Access Compliance Report

Public Rights-of-Way (Curb Ramps)

Intersection ID: 26714	Main Street: NANCY_CREEK_RD	Cross Street: OPEN_BOOK_LN	Location: NW
ADA ID: C114D1681F56	Ramp Type: BlendTrans1	Initial Pass/Fail: Fail	Overall Compliance: No
		Severity Score: 10

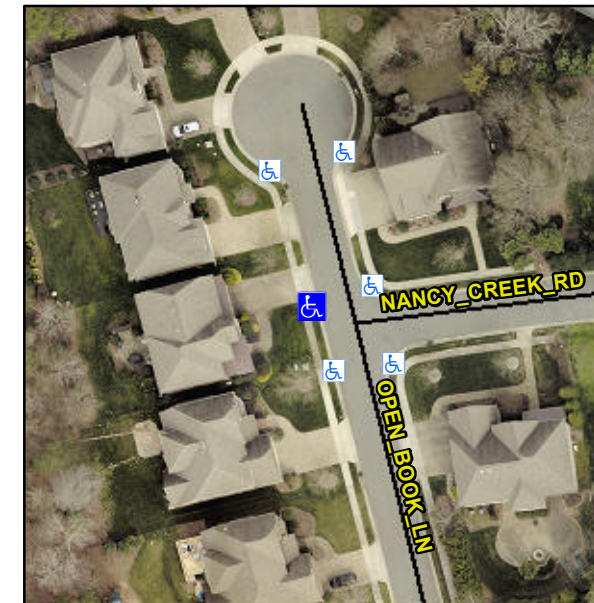
Not Found, R304.5.1

Compliance	Description	Data	Compliance	Description	Data
N/A	Ramp Length (in)	48.0	Yes	BlendTrans Slope (%)	3.1
No	Ramp Width (in)	47.5	Yes	BlendTrans XSlope (%)	3.2
N/A	Flare Type LT	N/A	N/A	Flare Type RT	N/A
N/A	Flare Slope LT (%)	N/A	N/A	Flare Slope RT (%)	N/A
N/A	Flare Traversable LT?	N/A	N/A	Flare Traversable RT?	N/A
N/A	Landing Length (in)	N/A	N/A	DWS Provided?	N/A
N/A	Landing Width (in)	N/A	N/A	DWS Contrast?	N/A
N/A	Landing Slope (%)	N/A	N/A	DWS Length (in)	N/A
N/A	Landing X Slope (%)	N/A	N/A	DWS Full Width?	N/A
N/A	Landing Curb? (Y/N)	N/A	N/A	DWS Offset (in)	N/A
N/A	Shared Landing?	N/A			
N/A	Gutter Ponding?	N/A	N/A	Gutter Slope (%)	N/A
N/A	Gutter Lip Ht (in)	N/A	N/A	Gutter X Slope (%)	N/A
N/A	Painted X Walk1?	No	N/A	Painted X Walk2?	N/A
	X Walk 1 Direction	To E		X Walk 2 Direction	N/A
	X Walk 1 Width (in)	N/A		X Walk 2 Width (in)	N/A
	X Walk 1 Slope (%)	3.2		X Walk 2 Slope (%)	N/A
	X Walk 1 X Slope (%)	5.4		X Walk 2 X Slope (%)	N/A

N/A	Ramp inside XWalk1?	N/A	N/A	Ramp inside XWalk2?	N/A
	Road Slope (%)	5.4		Clear Space?	N/A
	Road X Slope (%)	3.2	N/A	Clear Space to XWalk (in)	N/A
N/A	Any Obstructions?	N/A	N/A	Storm Grate/Utility Hazard?	N/A
	Obstruction Type			Storm Grate/Utility Type	
		N/A			N/A
			Yes	Surface Condition? (G/P)	Good
			No	Curb Slope (%)	18.2

Remove & Replace Curb Ramp With Two New Directional Ramps or Equivalent.
